# Codes and Standards Enhancement (CASE) Initiative For PY2011: Title 20 Standards Development

**Title:**  
**Comment Letter in Response**  
**To May 19, 2011 Committee Workshop**  
**For Battery Charger System Energy Efficiency Standards**  
**(Docket Number Docket 09-AAER-2)**

**RE: Battery Charger System Energy Efficiency Standards (Docket Number Docket 09-AAER-2)**

**Figure 1: Example of hysteresis operation of a NiMH power tool charger**

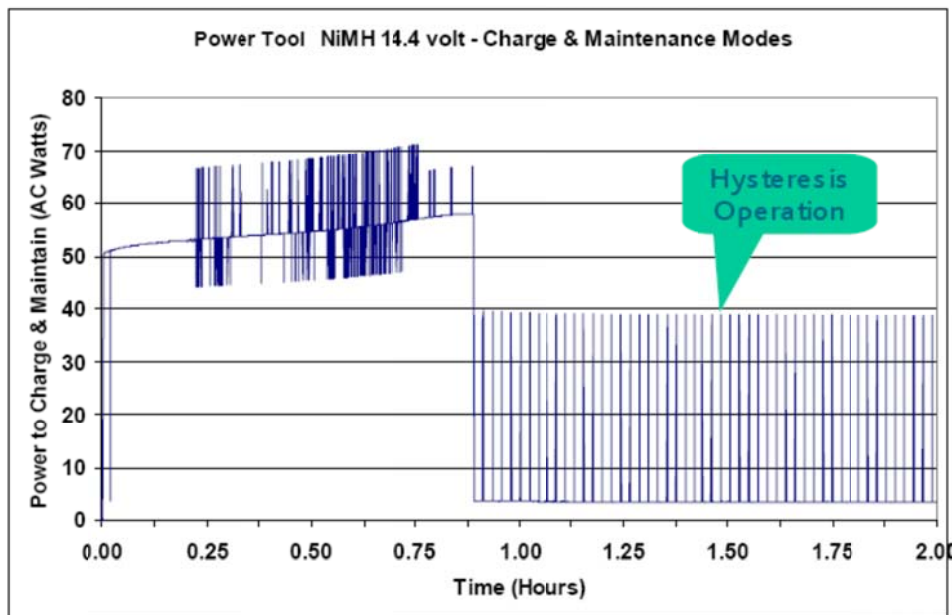
CEC PIER research concludes that nickel-based chemistries can be maintained with hysteresis charge profiles, which have lower overall energy use than constant trickle charge configurations currently used. Motorola mentioned this as a possible solution to increasing efficiency in the May 19 workshop. Below is a description of hysteresis charging from page 26 of Designing Battery Charger Systems for Improved Energy Efficiency, A Technical Primer, Geist et. all 2006.

Not only is hysteresis charging already employed in some nickel chargers today (Figure 1, above), but the IOU teardown and redesign of a NiCd charger detailed in the March 3, 2011 IOU presentation demonstrated the technical potential of hysteresis charging in the laboratory. The original design as-shipped incorporated approximately a 0.05C constant or “float” trickle to maintain charge. This level agrees with industry rule of thumb to counteract self-discharge cited in the May workshop. “Float” charge is relatively inefficient because much of the useful energy is lost as heat in the battery to keep the voltage very high and at these charge levels, the ac-dc power supply operates at a less efficient partial load. This results in high battery maintenance and low 24 hour efficiencies (Figure 2). The IOU technical team modified this product to employ

Figure 2: As-shipped DIY power tool with constant current charge solution

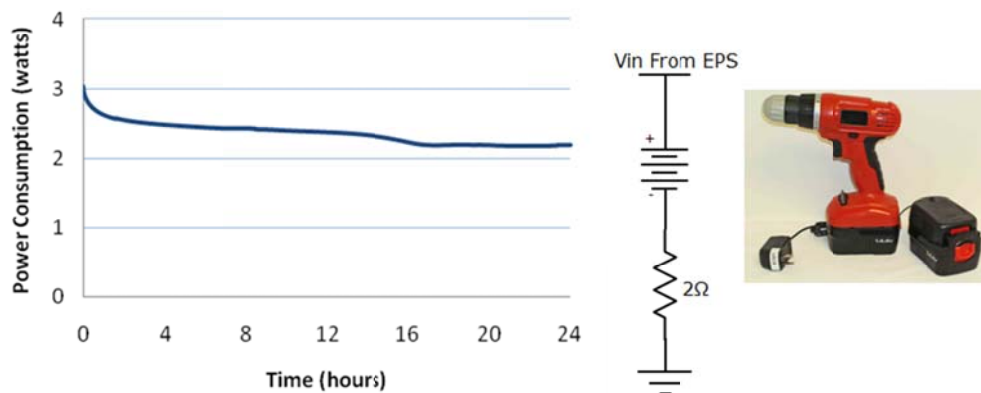
a hysteresis charging algorithm as an alternative. This algorithm, coupled with more efficient ac-dc power conversion, improved the 24 hour efficiency by nearly 20 percentage points. Battery maintenance was reduced, and the no-battery mode was maintained at 0.3 watts (table below). When the battery was discharged after the 24 hour charge cycle, it was confirmed within equipment confidence intervals that the battery was at the same state of charge as observed in the as-shipped configuration, which used “float” charge.

**Figure 3: Motorola discharge energy presented at workshop not consistent with test procedure, underestimates extractable battery energy**

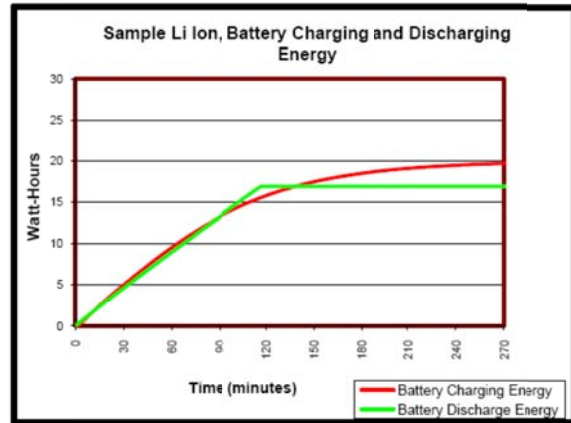
Motorola's assertion that nickel chemistries need a higher 24 efficiency level is based on 1 to 2 hour discharge rates not consistent with the test procedure. In Figure 3 below taken from the Motorola workshop presentation, the NiMH is discharged with a 1C rate (approximately 60 minute discharge) and the Li-Ion battery is discharged with a 0.5 C rate (approximately a 120 minute discharge). Employing the fastest acceptable discharge rate for NiMH (1C) and comparing that capacity measurement to a slower discharge rate of the Li-Ion (0.5C) over-emphasizes the differences between these two chemistries. Furthermore, the actual 24-hour test requires a much slower discharge of 0.2 C.

Motorola and other stakeholders are correct that nickel-based batteries have different characteristics than Li-Ion batteries. The CEC-proposed value for 24 hour efficiency is based solely on the 0.2C discharge energy of the battery ( $12 + 1.6 E_b$ , where  $E_b$  is the battery energy measured by the test procedure). This slow discharge helps reduce difference among battery chemistries, and is appropriate when compared to the test procedure discharge rates.
